Wisconsin Department of Transportation

Proposal #10: 1060-34-84
Zoo IC, Center Street Bridge
Over USH 45
USH 45
Milwaukee County

1060-35-85
Zoo IC, Center Street Sidewalk
114th Street to 117th Street
Off System
Milwaukee County

This is Addendum No. 01, which provides for the following:

Addendum No. 01
 ID 1060-34-84 &
 ID 1060-35-85
 Revised Sheet 167
 November 30, 2015

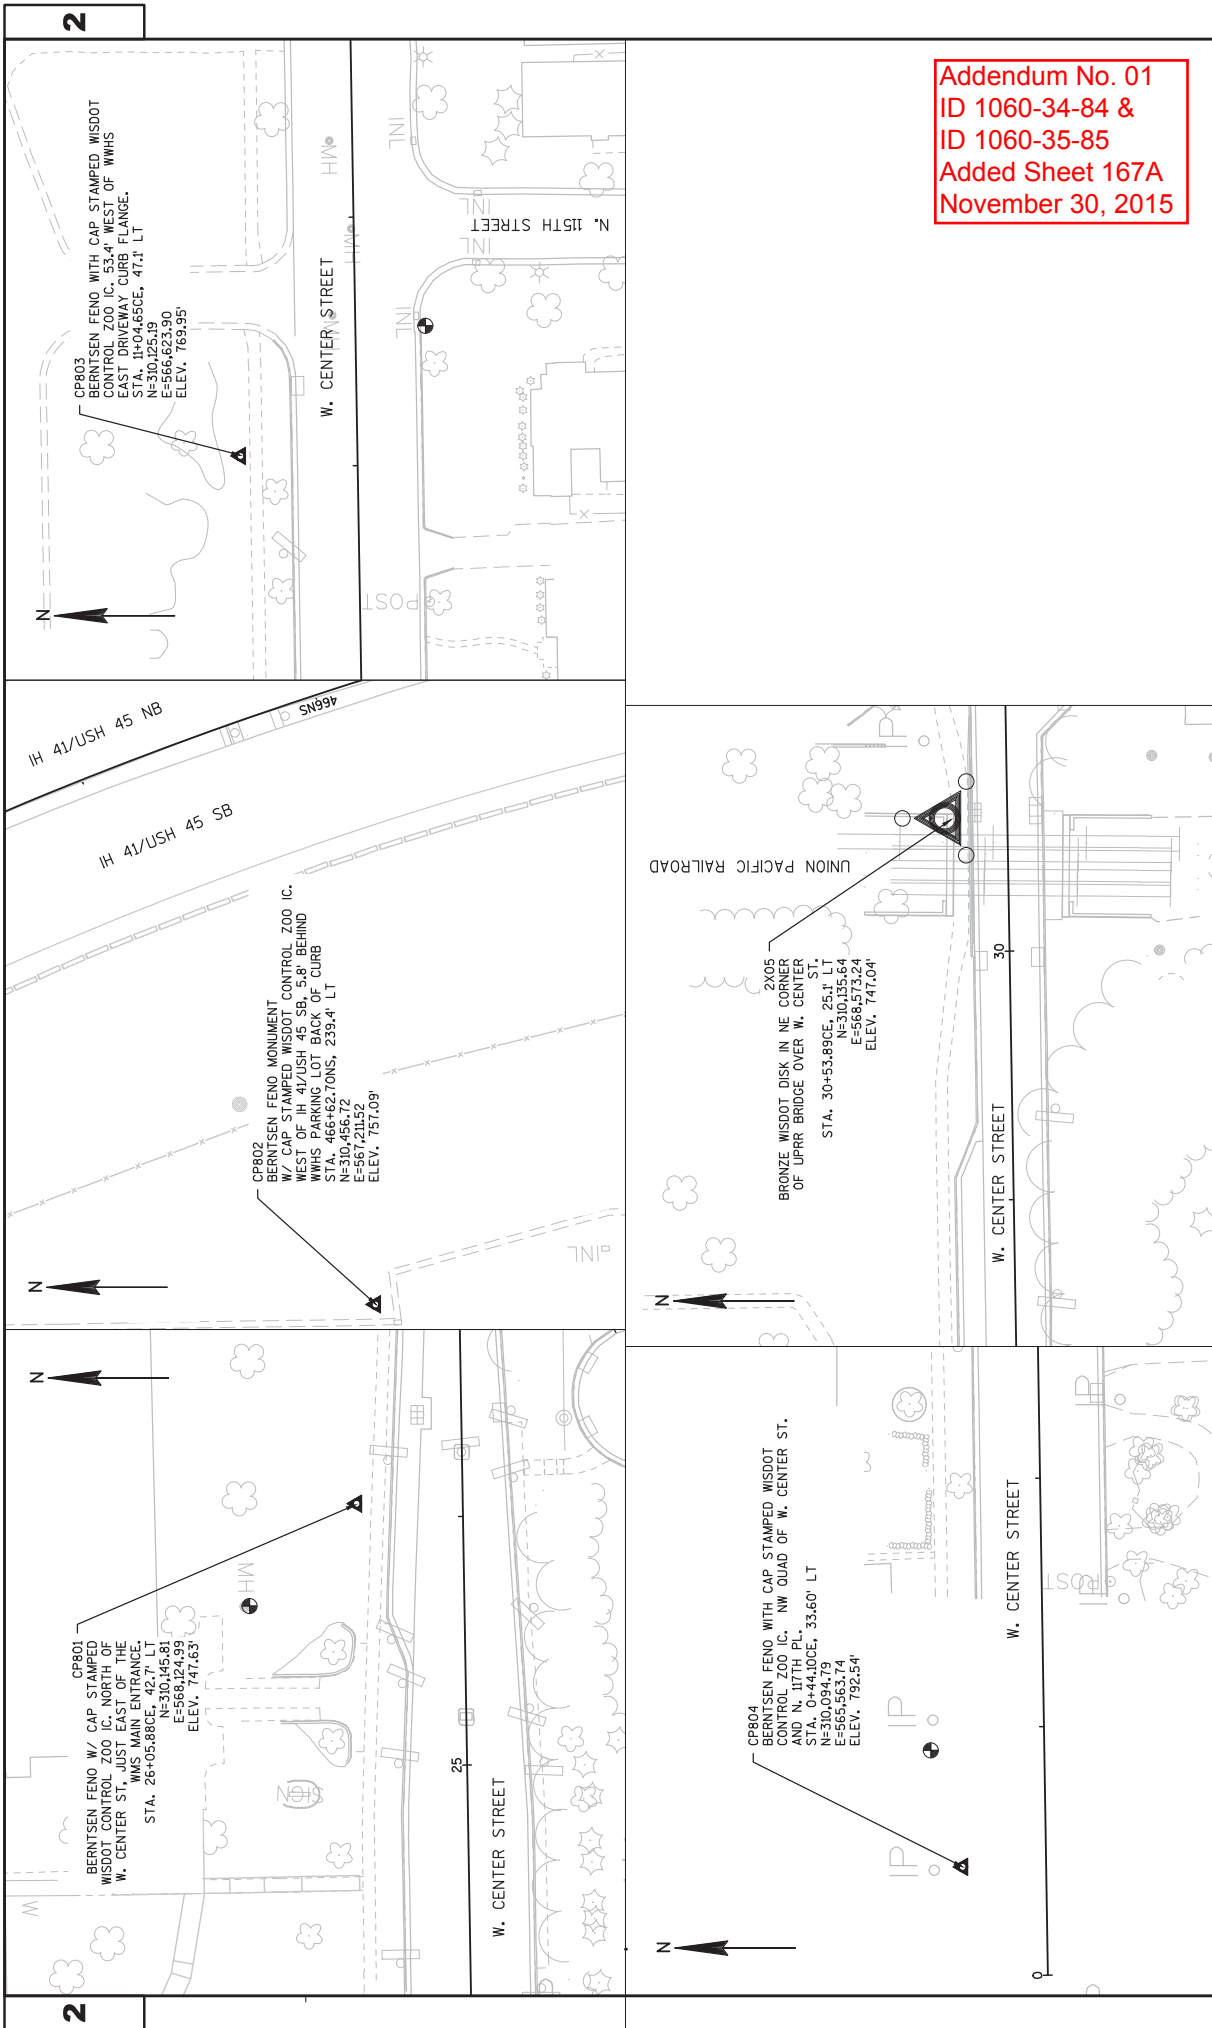
| Revised Plan Sheets | |
|---------------------|---|
| 167 | Alignment Layout - Survey Control – removed incorrect background mapping |

Addendum No. 01
 ID 1060-34-84 &
 ID 1060-35-85
 Revised Sheet 229
 November 30, 2015

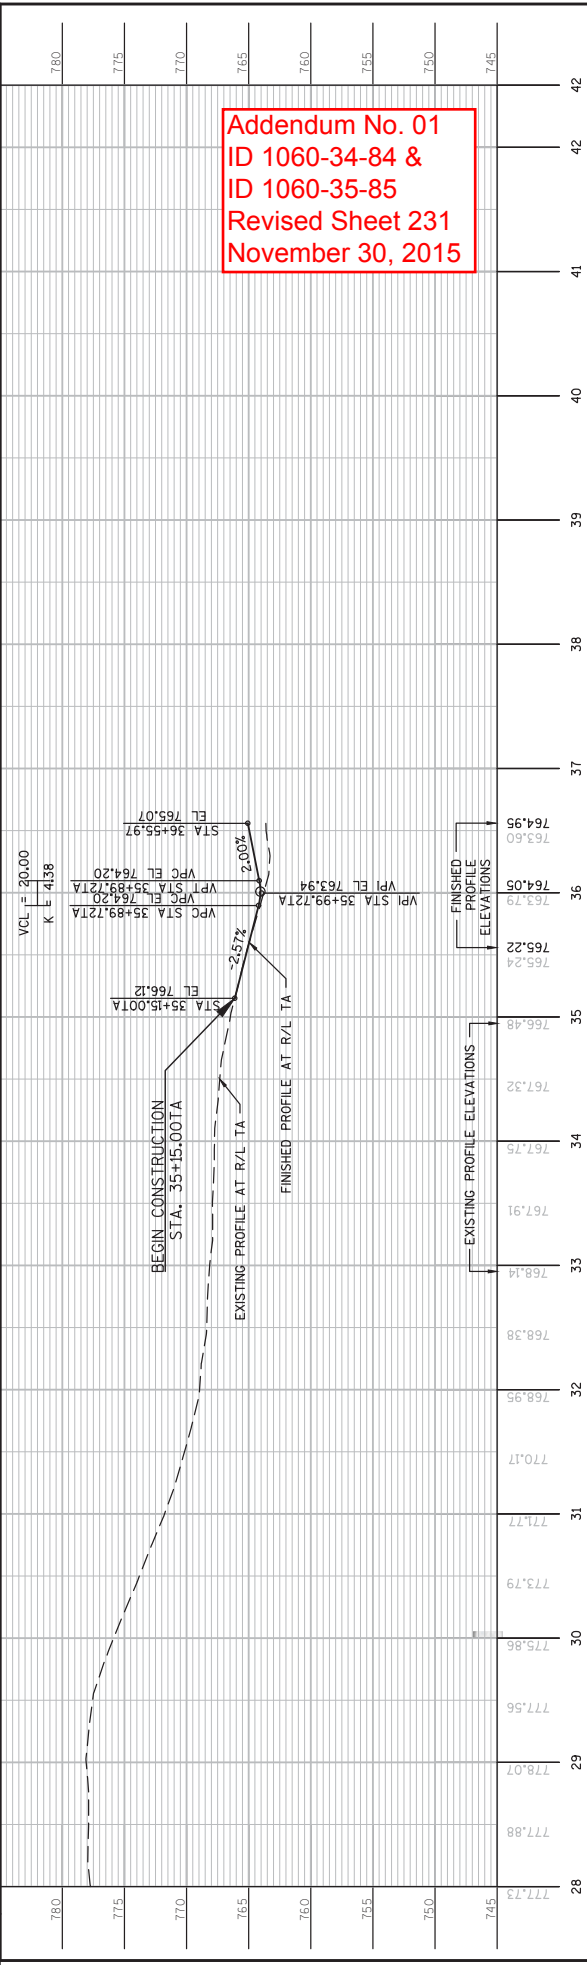
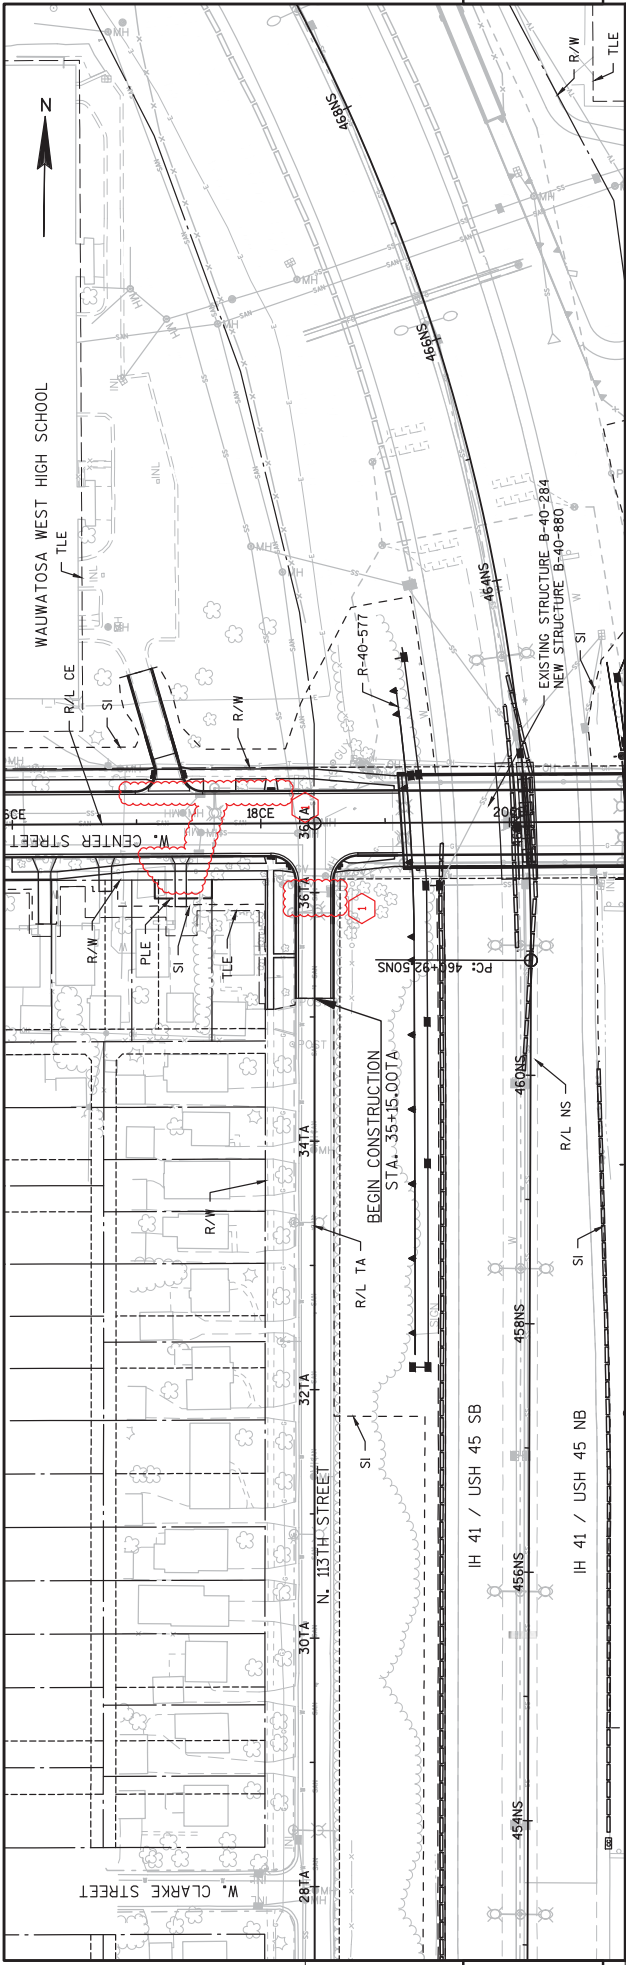
| 229 | Plan and Profile: W. Center Street – Removed sections of proposed storm sewer due to Wauwatosa storm sewer project |
